Title - Sujet Recruiting Centre Fit-Up, JCB	
Solicitation No. - N° de l'invitation ED001-151689/A	Amendment No. - N° modif. 003
Client Reference No. - N° de référence du client R.070493/R.071965.1	Date 2015-01-20
GETS Reference No. - N° de référence de SEAG PW-\$PWC-010-3539	
File No. - N° de dossier PWC-4-37141 (010)	CCC No./N° CCC - FMS No./N° VME
Solicitation Closes - L'invitation prend fin at - à 02:00 PM on - le 2015-01-22	Time Zone Fuseau horaire Atlantic Standard Time AST
F.O.B. - F.A.B. Plant-Usine: <input type="checkbox"/> Destination: <input checked="" type="checkbox"/> Other-Autre: <input type="checkbox"/>	
Address Enquiries to: - Adresser toutes questions à: MacDonald, Anne (PWC) D.	Buyer Id - Id de l'acheteur pwc010
Telephone No. - N° de téléphone (902) 626-4949 ()	FAX No. - N° de FAX (902) 566-7514
Destination - of Goods, Services, and Construction: Destination - des biens, services et construction:

Addendum # 3
January 20, 2015

Drawing A-1, Demo Plan Details

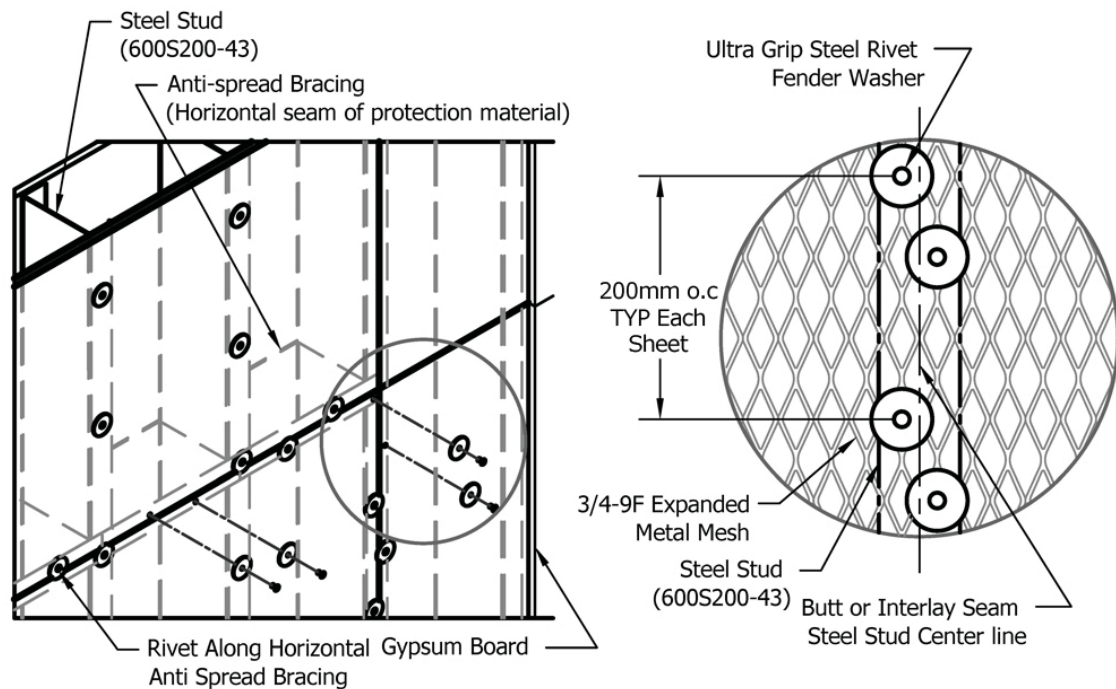
Refer to Wall Type B, where it specifies Wire Mesh on Attack Side. The wire mesh shall be:

Flattened Metal Mesh: To EMMA 557-99. Style ¾-9F: nominal strand thickness of 0.120" (0.108" to 0.132"). Diamond opening of 0.563" x 1.688".

Mount on the outside (attack side) of the room. Support all edges by anti-spread bracing, studs or corners. Align the sheet edges at every vertical and horizontal seam on the centre line of the steel stud or anti-spread bracing and secure all sheets with welds or rivets.

Note: Screws (including "security screws") are **NOT** acceptable for permanently attaching the protection material (steel or steel mesh). Screws may be used to "tack" the sheets in place pending riveting or welding. Temporary screws do not need to be removed.

Mesh shall be riveted to steel studs as follows and as shown in diagram:

Rivet: 3/16" steel pop rivet: Speaneur part #301-440

Washers: 1 ½" OD, 3/16" ID "fender" washer: Fastenal part #1133204
